MEMORANDUM

TO: District of Columbia Zoning Commission
FROM:  Jennifer Steingasser, Deputy Director
DATE: September 10, 2012
SUBJECT: **Final Report** for ZC #04-14B, Florida Rock Properties, Inc., et al – PUD Modification @ Square 708, Lot 14

SUBJECT: ZC #04-14B, Florida Rock Properties, Inc., et al – PUD Modification @ Square 708, Lot 14

Approved (2008) and Proposed (2012) PUD Footprints

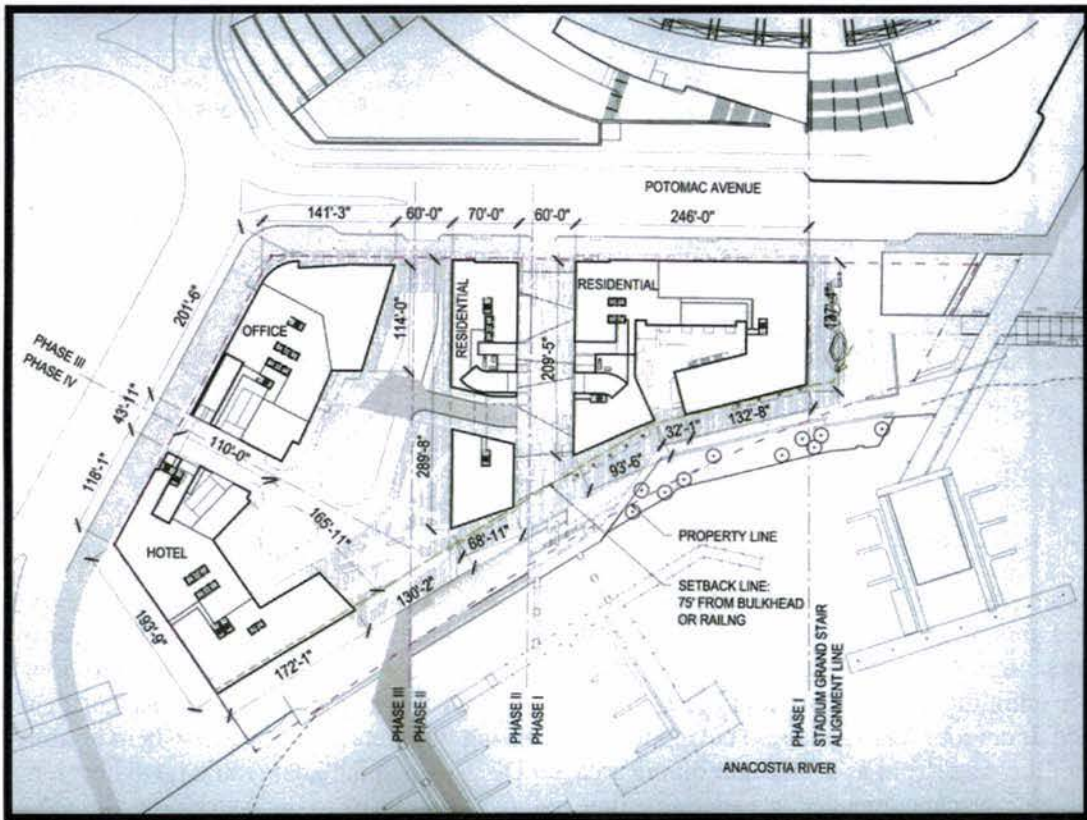
- A simplified building footprint, with elimination of most of the curved or lozenge shaped building forms and a somewhat more defined streetwall along Potomac Avenue and a reduction in lot occupancy;

The remaining phases are being submitted for a First-Stage PUD approval, unlike the previous Second-Stage approval. The modification of the site design better utilizes the site's natural features, as it appropriately draws the visitor to the water's edge. OP is supportive of this modification, as it will allow Zoning Commission review of future phases of development which better respond in design specifics to the changing character of the area.

The approved Second-Stage PUD uses have not significantly changed for these phases. The overall density of Phases II-IV approved by the Second-Stage PUD (3.4 FAR) has been minimally increased in the proposed modification to a First-Stage PUD (3.5 FAR), and the proposed height of the office building in Phase II has been increased from 112 feet to 130 feet. The lot occupancy would be reduced from about 59% to about 44%.

OP supports the redesign of these phases, including the open space areas, as it reduces the visual massing and provides improved pedestrian and visual opportunities to the public in accessing the river's edge.

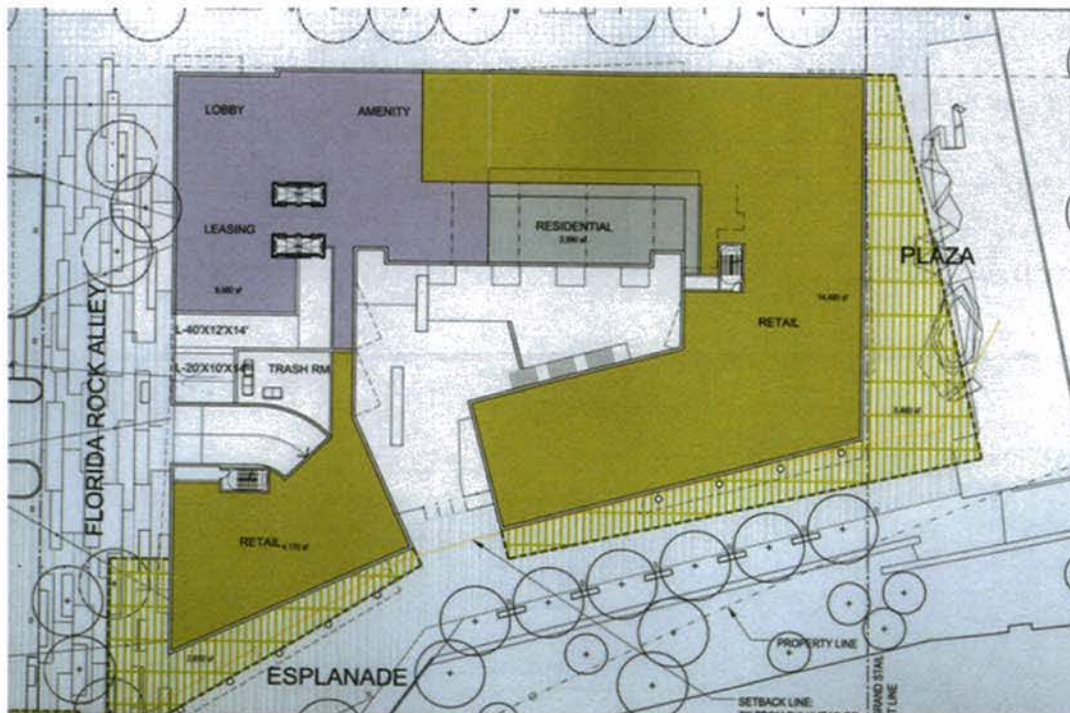
The proposed conversion of the approved East Office Building would include primarily a residential building at 94.85 feet in height, 45.77% lot occupancy and 1.18 FAR². The residential building would include about 324 residential units. Eight percent of the residential gross floor area would be assigned to households making no more than 80% of the Annual Median Income (AMI) or the life of the project in accordance with the Inclusionary Zoning (IZ) provisions.

The building’s U-shaped design is oriented towards the river to afford favorable views for the maximum number of units. Additional detail for the residential courtyard is provided which proposes controlled access to a landscaped respite for residents from the bustle of the plaza and esplanade (L2.14). The roof top amenity space is also detailed and would provide additional area for relaxation for residents (L2.15).

The revised plans show approximately two thirds of the ground floor frontage along Potomac Avenue dedicated to retail and would wrap around the portion of the building facing the plaza, the river front, as well as a portion of the Florida Rock Alley, for approximately 18,650 square foot of ground floor retail space. In addition, 8,130 square foot of the plaza area to the east and a portion of the esplanade would be dedicated to outdoor retail space. The applicant is working with retail developers to help establish this section of the waterfront as a “premier dining area” in DC. As such the goal would be to develop an interactive streetscape intended to entice first time and recurring visits to the waterfront.
